Access Compliance Report

Public Rights-of-Way

(Curb Ramps)

Intersection ID: 30314	Main Street: ROCKET_LN	Cross Street: SHINKANSEN_DR	Location: S
ADA ID: BE5C98AC45EF	Ramp Type: BlendTrans1	Initial Pass/Fail: Fail	Overall Compliance: No
Severity Score: 8.75			
Codes/Mitigation Info/Possible Solution		Field Measurements/Component Compliance

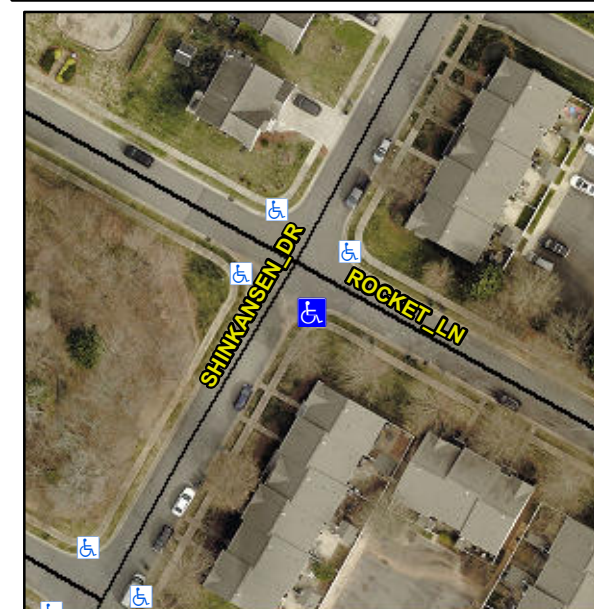
RP < 5%, LNDG GAP 1.0

Not Found, R304.5.1

Remove & Replace Curb Ramp With Two New Directional Ramps or Equivalent.
